MODIFICATION RECOMMENDED

N5221A-02A

S E R V I C E N O T E

N5221A PNA Series Microwave Network Analyzers

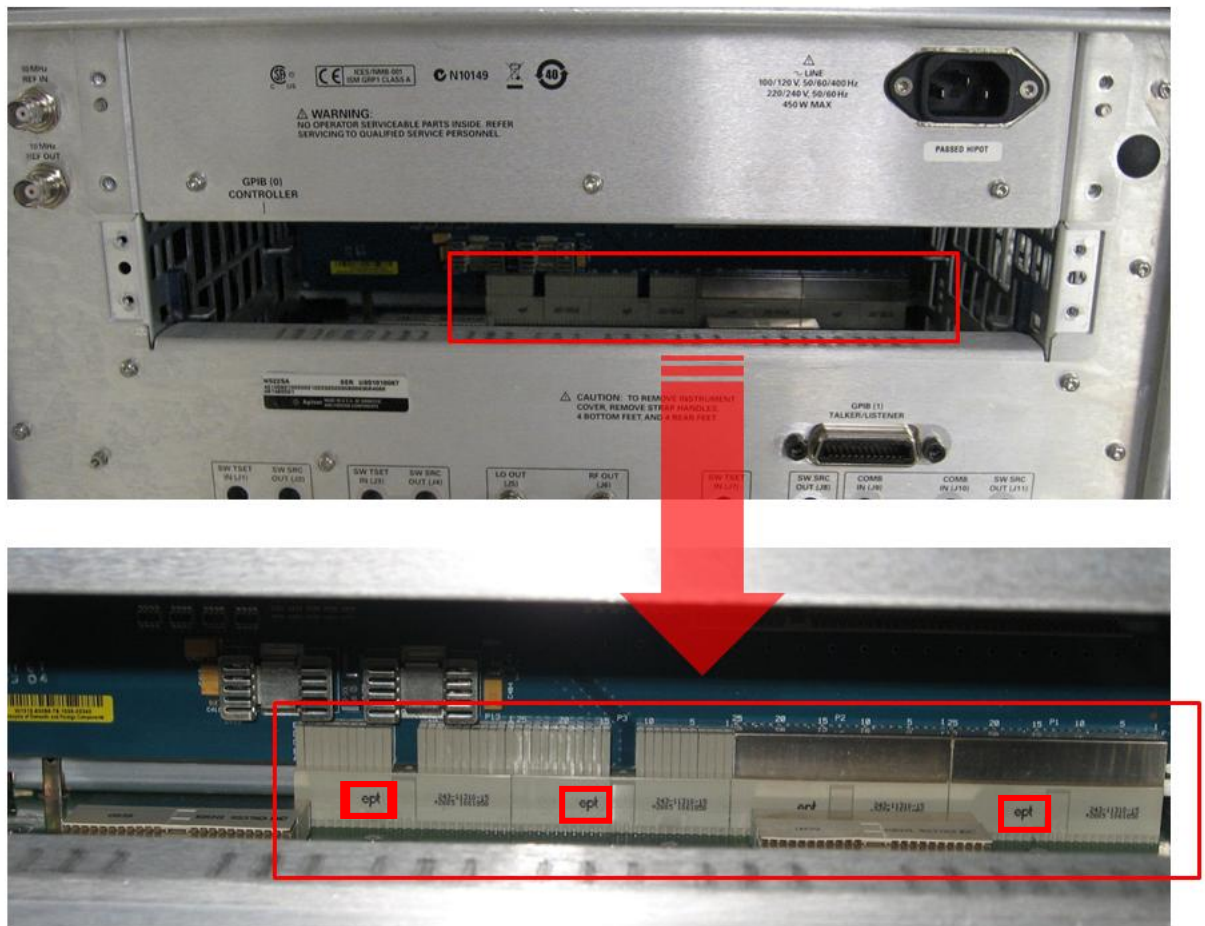
1. Remove the CPU assembly from the analyzer's rear panel. Refer to the PNA Service Guide chapter 7 section titled, "Removing and Replacing the CPU Board Assembly" for removal and reinstallation procedures. To view the online Service Guide, see the numbered list on the next page for instructions.
2. As per the photo below, inspect the system motherboard connector to see if it has one or more "ept" logos.

3. If the connector has one or more “ept” logos, return the analyzer to Agilent for replacement of the system motherboard. If the connector does not have one or more “ept” logos, email ctd-soco_support@agilent.com, providing the analyzer model and serial number and details of the malfunction symptoms.

4. *For Agilent Service Technicians only:* Only new boards without “ept” logos should be installed. Before installing the new board, look to see if it has one or more “ept” logos. If so, email ctd-soco_support@agilent.com, providing the analyzer model and serial number. Wait for further instructions in an email reply. New boards without “ept” logos can be installed. For installation instructions, refer to the PNA Service Guide chapter 7 section titled, “Removing and Replacing the System Motherboard.” To view the online Service Guide, see the numbered list on the next page for instructions.
